Review and Comment on proposed addition to the Mission Branch Library

Architectural Review Committee (ARC) of the Historic Preservation

March 11, 2020

The Planning Department (Department) requests review and comment before the Architectural Review Committee (ARC) regarding a proposal for 300 Bartlett Street (Assessor's Block 6515, Lot No. 001) to construct a two-story with sub-grade basement horizontal addition on the west and south facades for use as additional community space and staff facilities, restoration of the historic entry from 24th Street, interior renovations and reconstruction of a central stair based on historic documentation. The subject property is Landmark No. 234 (designated in 2002), also known as the Carnegie Mission Branch Library. 300 Bartlett Street is in a P (Public) Zoning District and a 55-X Height and Bulk District, is currently owned by the City and County of San Francisco and is operated by the San Francisco Public Library.

PROPOSED RESTORATIVE ASPECTS OF PROJECT - MAIN STAIR

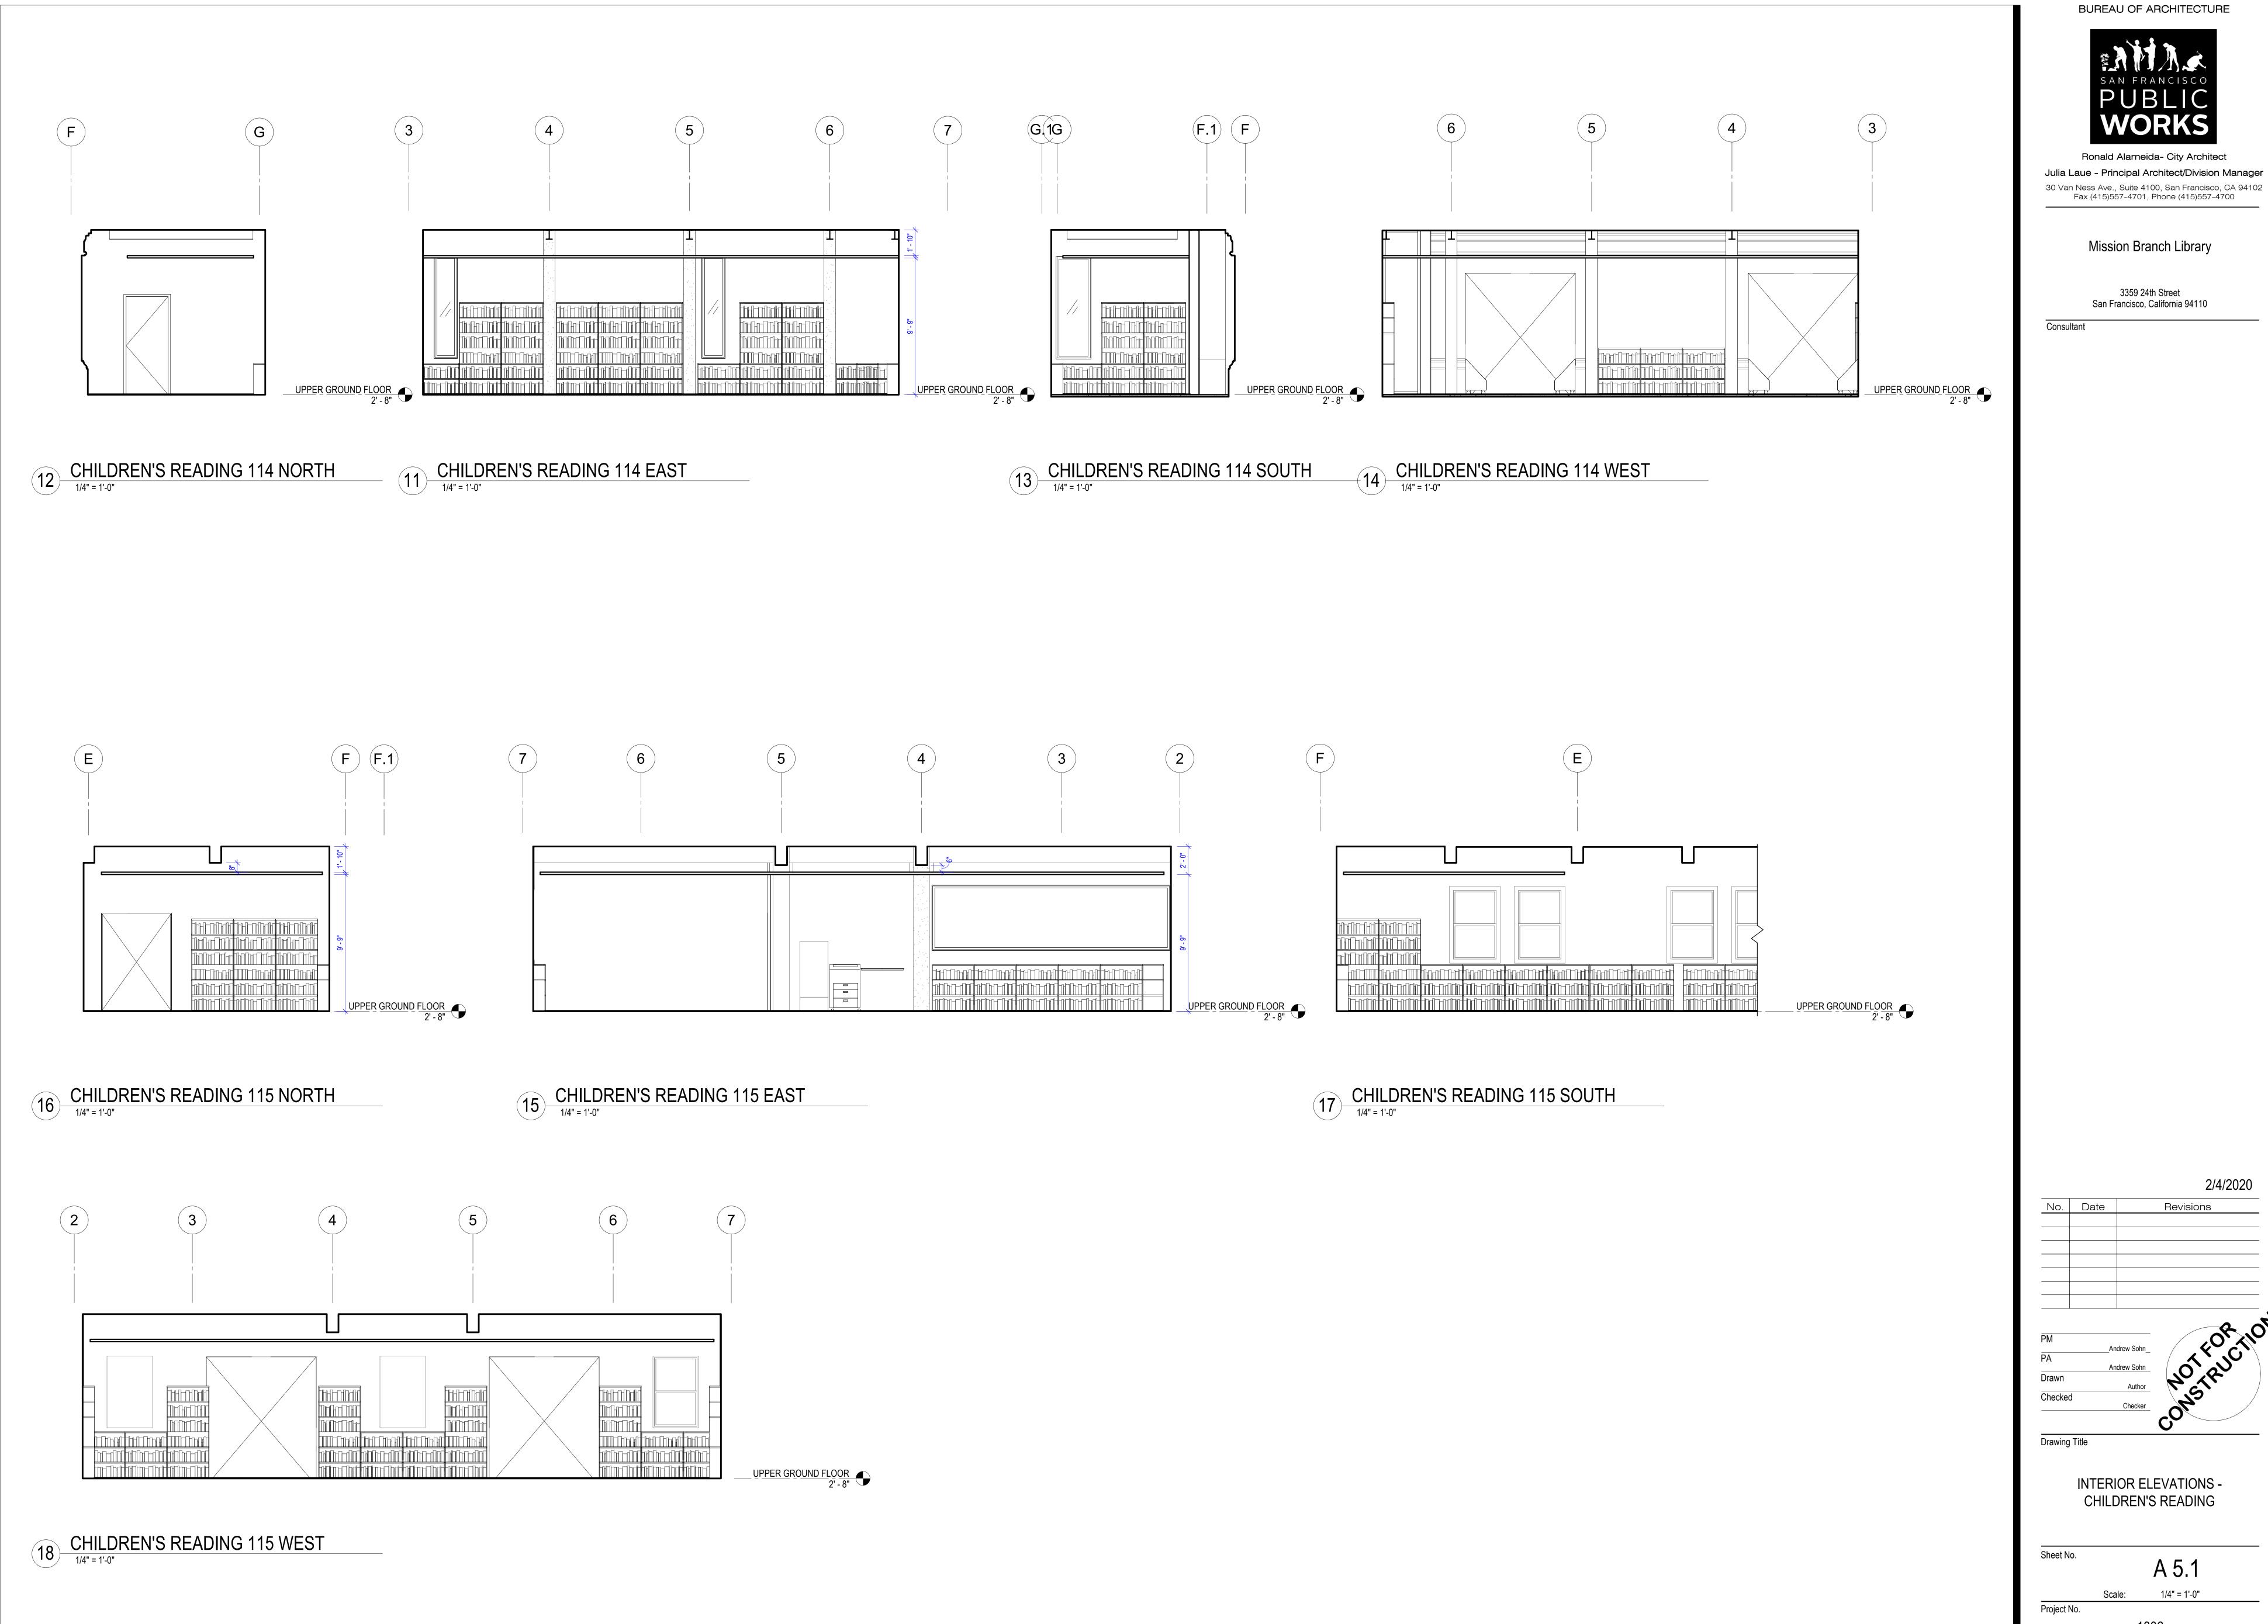
- Reconstruction of the Historic Central Stair: The project proposes to re-introduce the historic central stair that was removed and relocated in the 1990s. The reconstruction of the stair will be based on historic photos and on existing plans illustrated during review of the modifications conducted in the 1990s. The stair will be reconstructed using new stair with stone treads and risers, wood handrail along the existing refinished wall, and reinstallation of six extant original 1914 stone main stair balustrade panels with a new glass guardrail on top at the second floor landing. A new glass balustrade and guardrail infill wall is also proposed at the second floor landing where additional extant original stone balustrade panels are not available.

- **Staff Recommendation:** Staff requests input from the ARC regarding the reconstruction of the historic central stair. Staff recommends that compatible stone balustrade panels that match or closely match the extant panels to be reinstalled be proposed. Staff also requests additional information be provided on the proposed stone of the new stair (treads and risers).

- See drawing A4.01 for diagrams of restorative planning concepts. Also see attached images of original building.
